# **SERVICE BULLETIN**

No. SB-AG-58

Revision A 10/15/2015

ELEVATOR, RUDDER, AND AILERON CONTROL SYSTEMS
INSPECTION AND HARDWARE REPLACEMENT TO
INCORPORATE CASTELLATED NUTS IN JOINTS SUBJECT
TO ROTATION

#### 6.1 ELEVATOR CONTROL SYSTEM

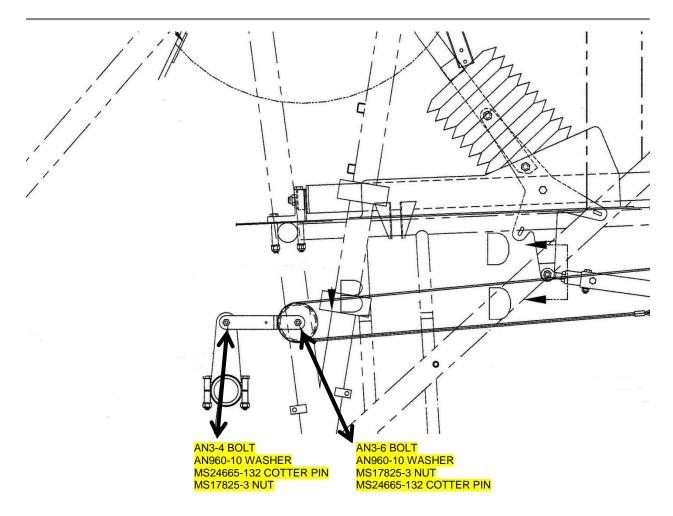
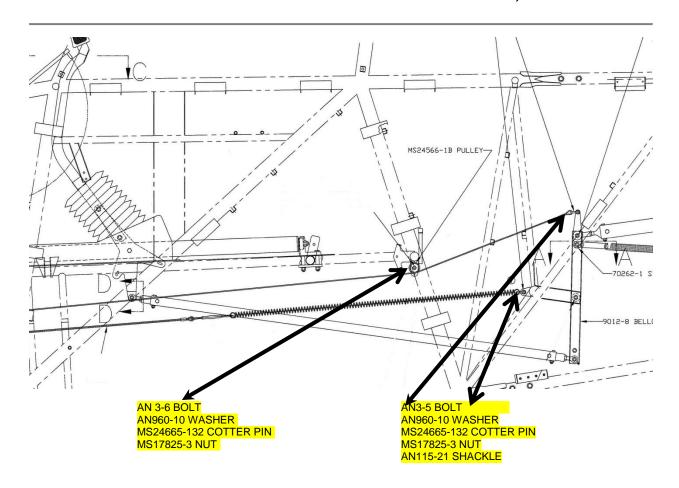
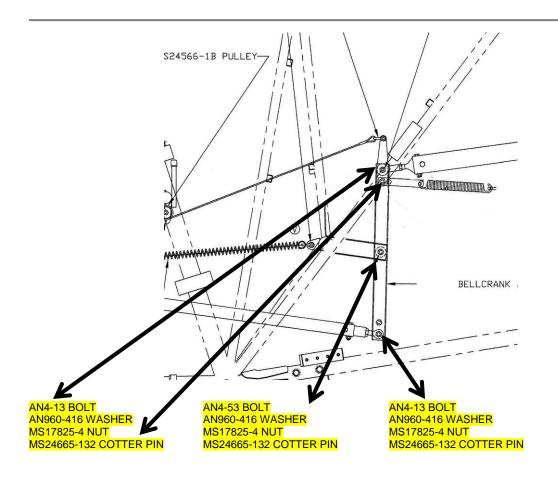
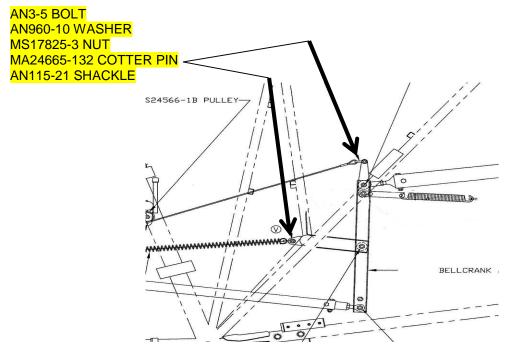
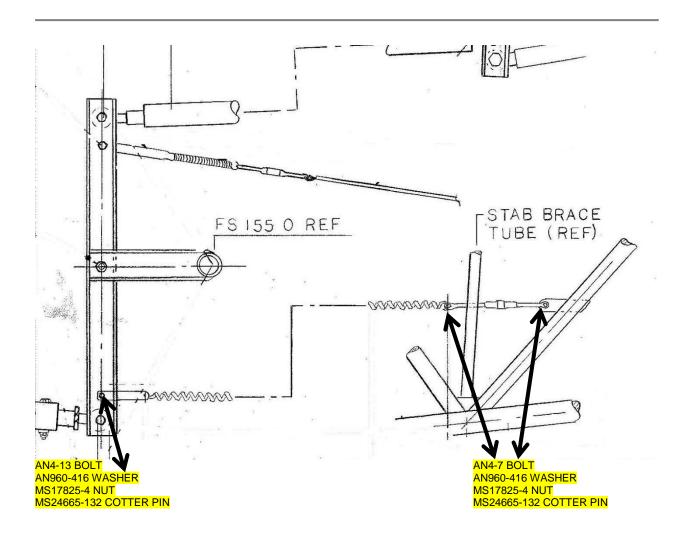
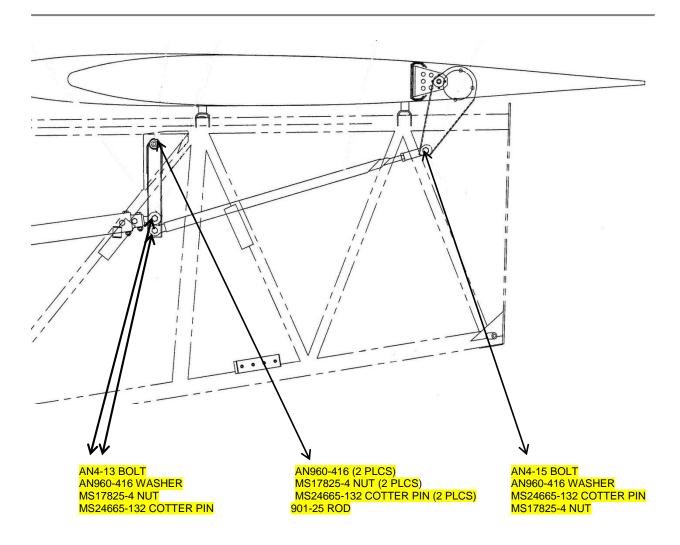
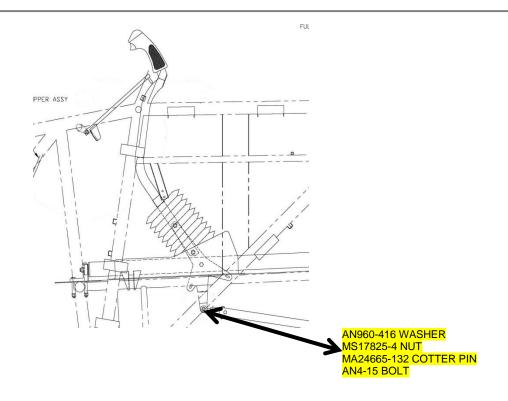
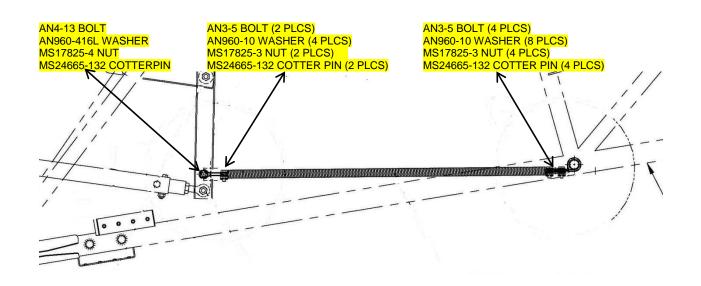
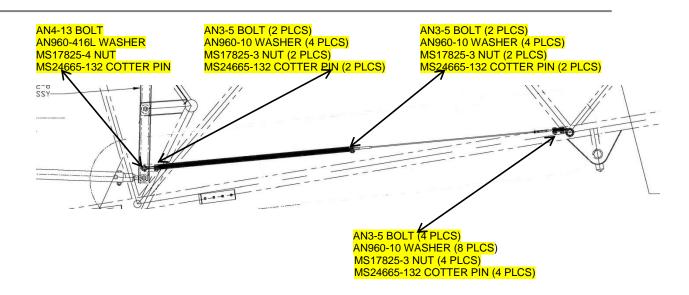
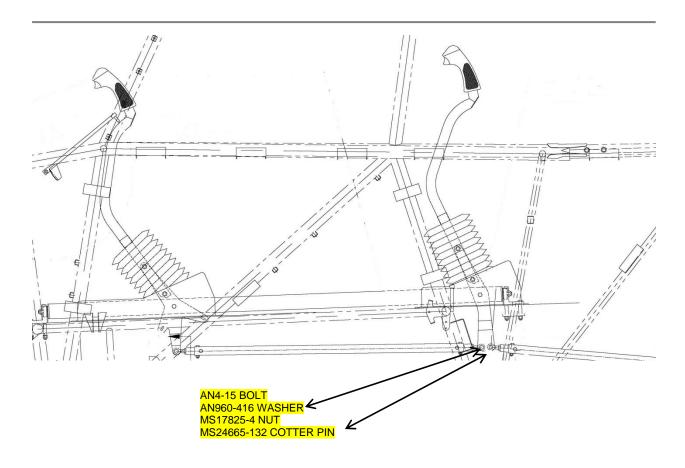
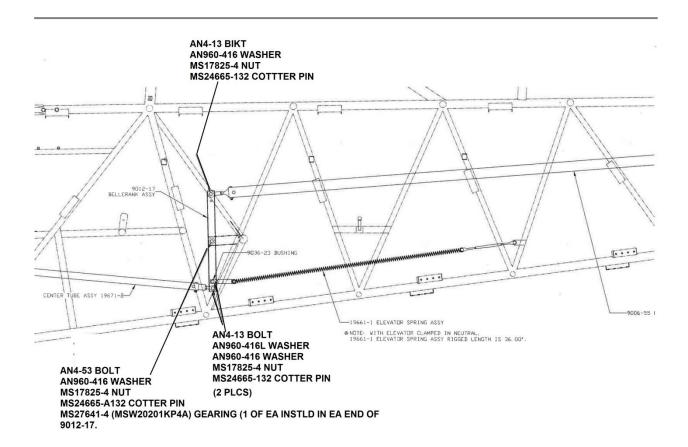
Inspect the applicable hardware using the diagrams below and replace existing hardware if it does not conform to the highlighted information.

- ① Remove existing nut and bolt and replace with hardware shown in applicable figure.
- ② Install cotter pin.

#### 6.2 RUDDER CONTROL SYSTEM

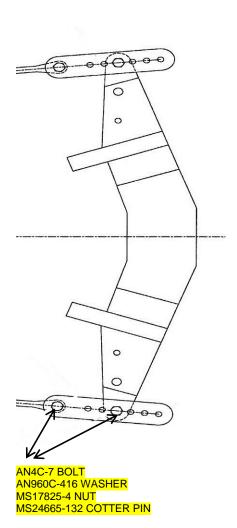
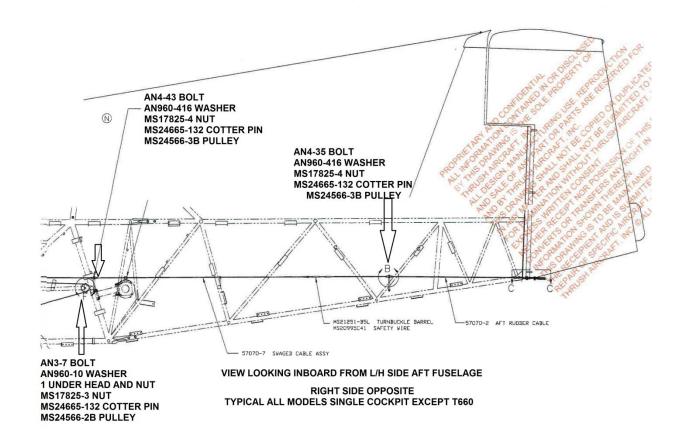
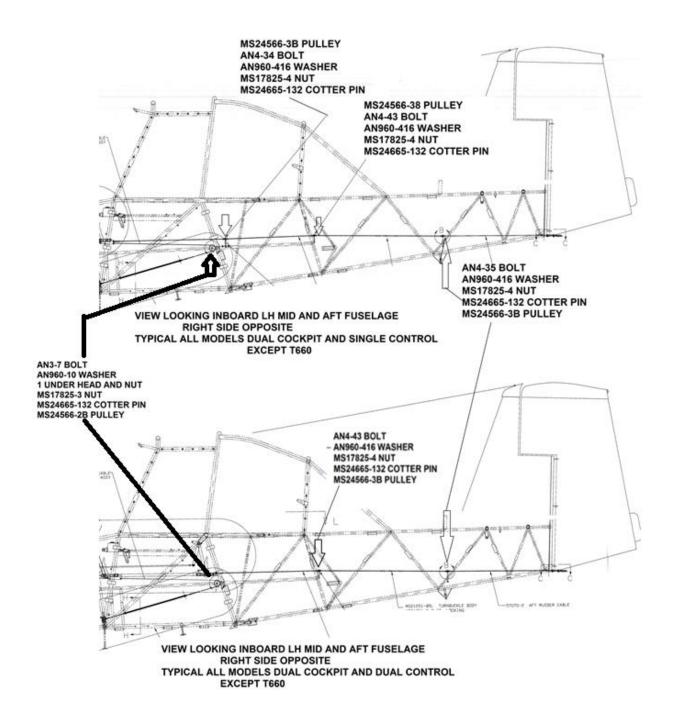
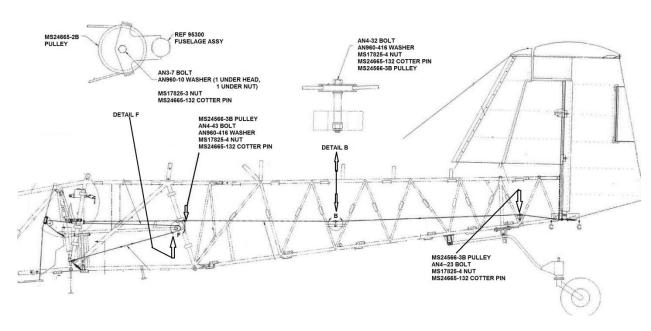
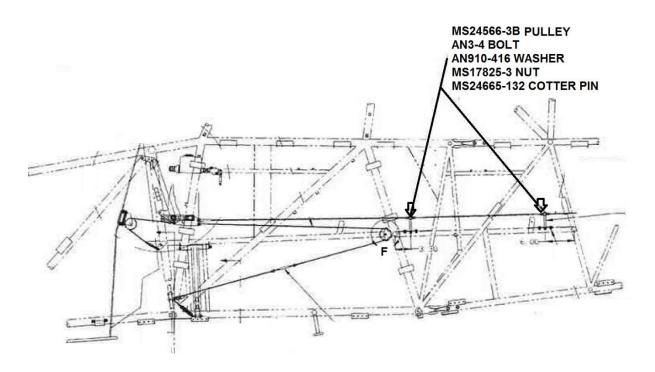
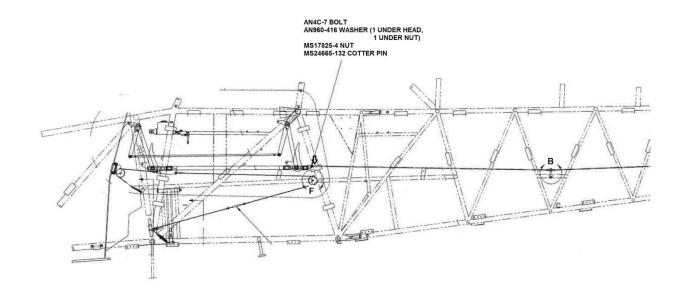
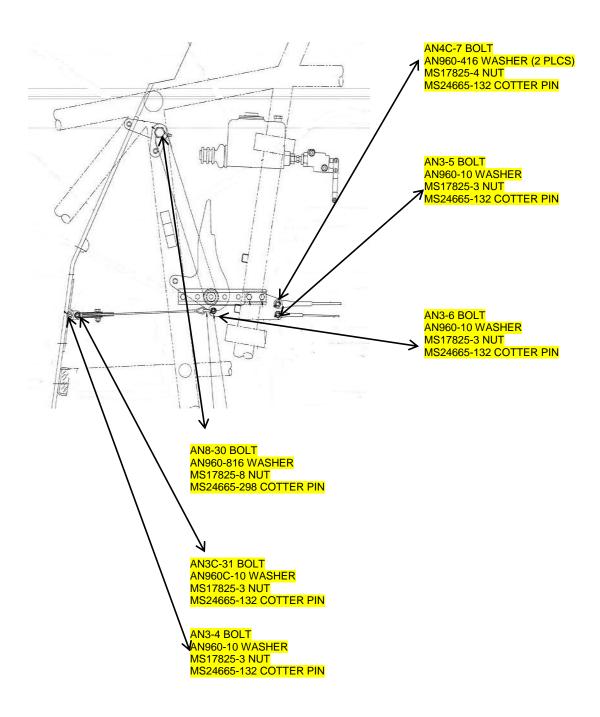
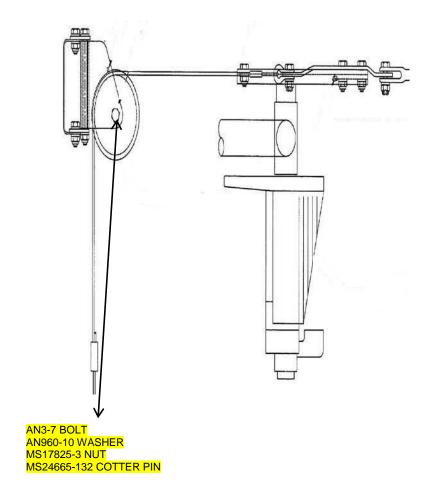
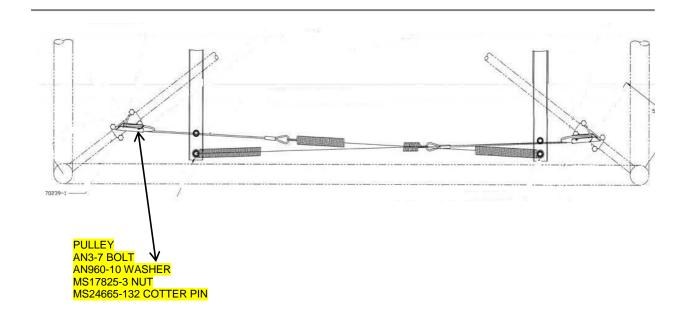
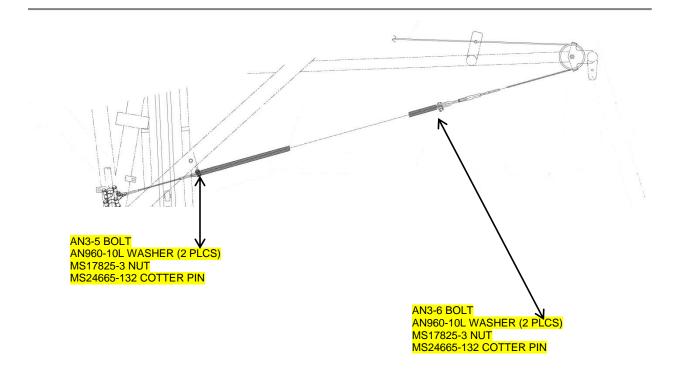
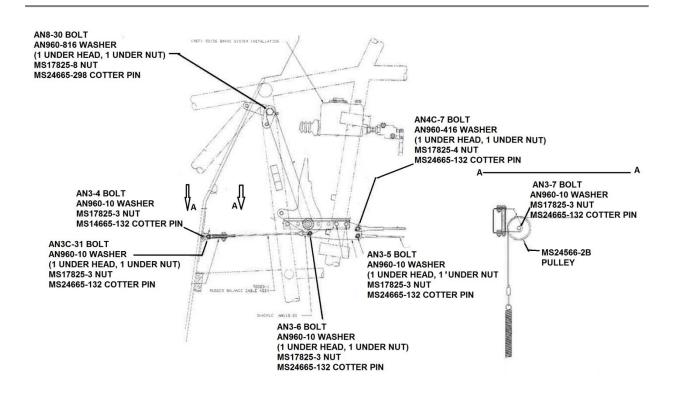
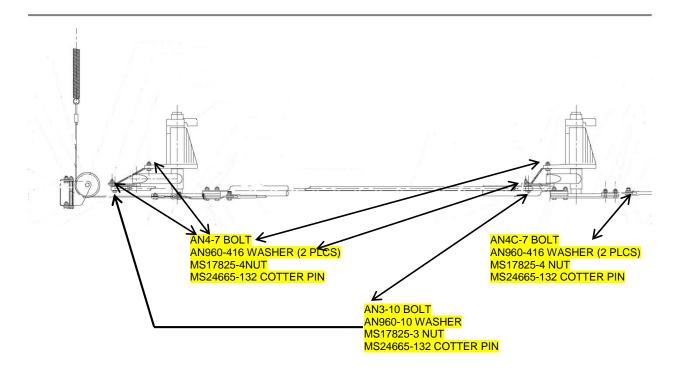
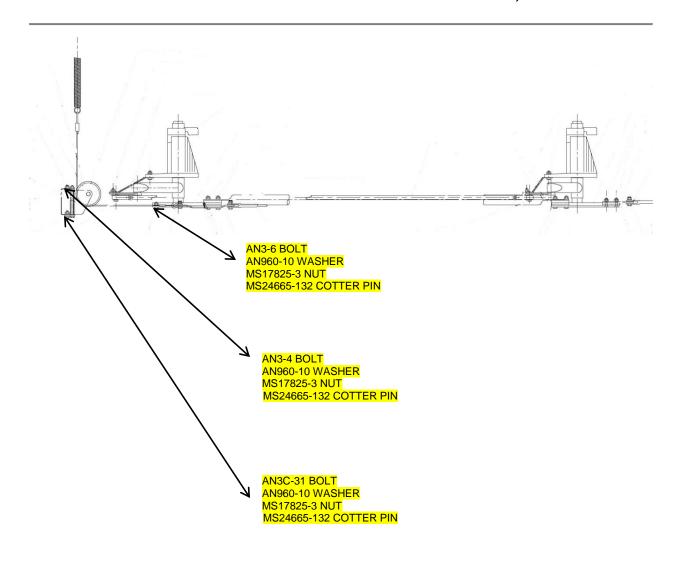
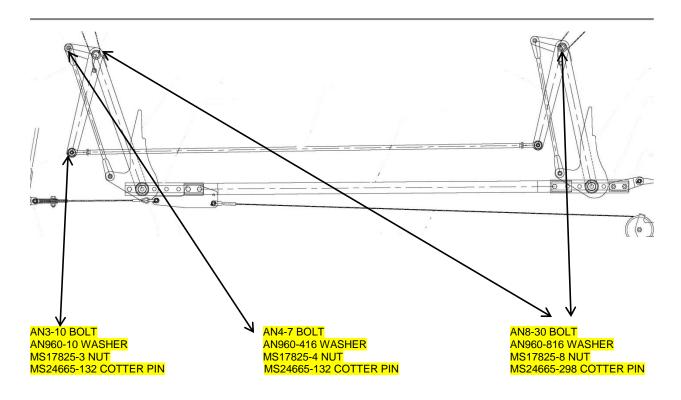
Inspect the applicable hardware using the diagrams below and replace existing hardware if it does not conform to the highlighted information.

- ① Remove existing nut and bolt and replace with hardware shown in applicable figure.
- ② Install cotter pin.

#### 6.3 AILERON CONTROL SYSTEM

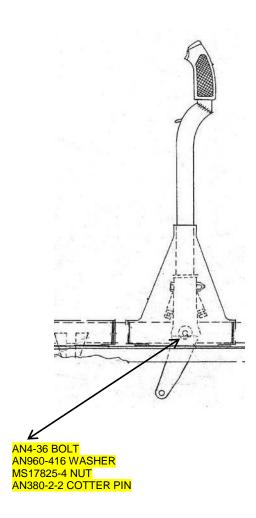
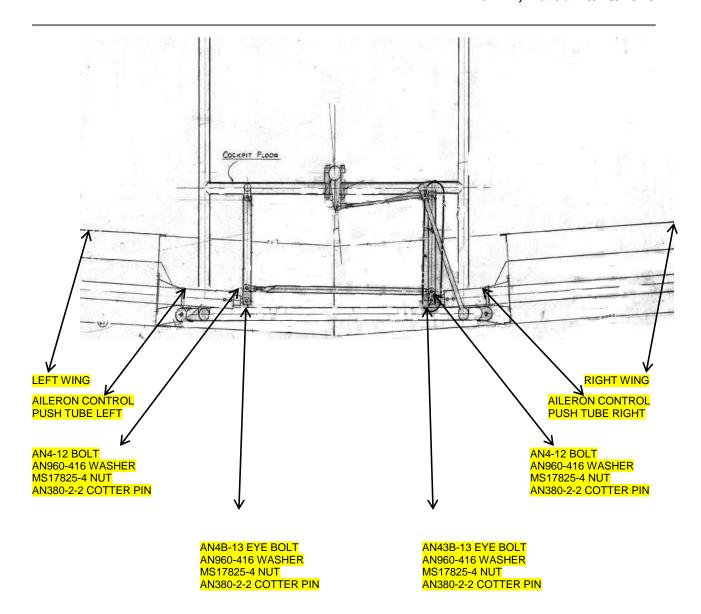
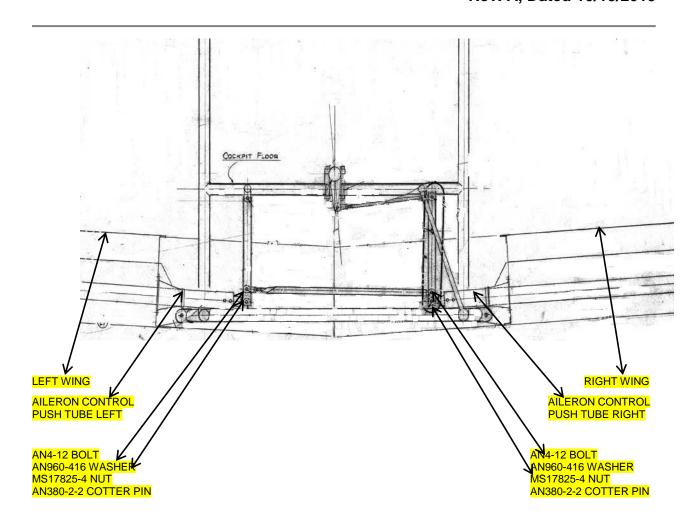
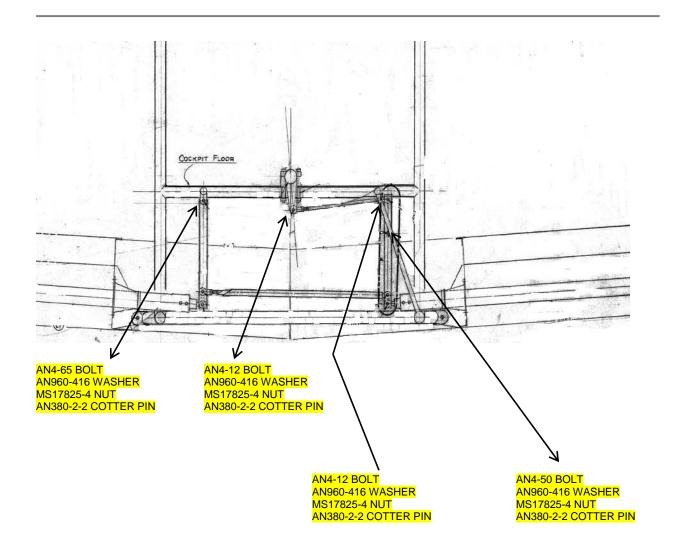
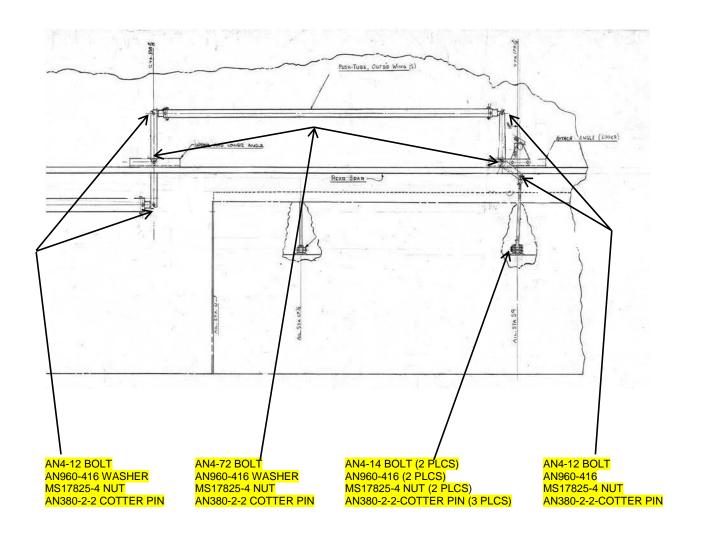
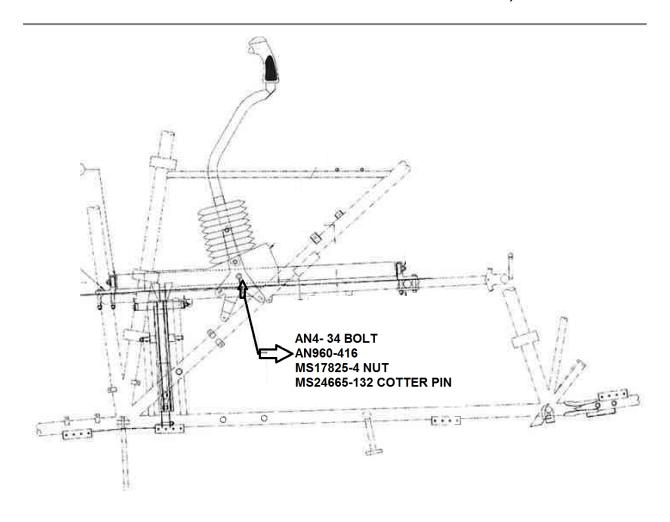
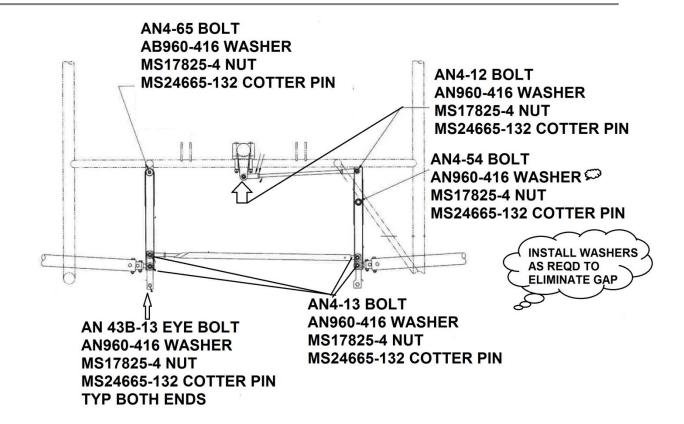
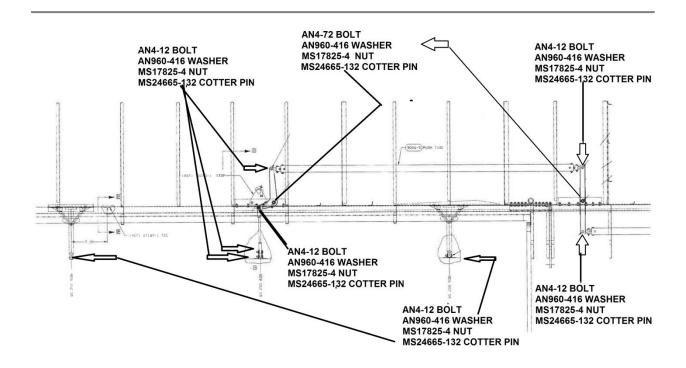
Inspect the applicable hardware using the diagrams below and replace existing hardware if it does not conform to the highlighted information.

- ① Remove existing nut and bolt and replace with hardware shown in applicable figure.
- ② Install cotter pin.
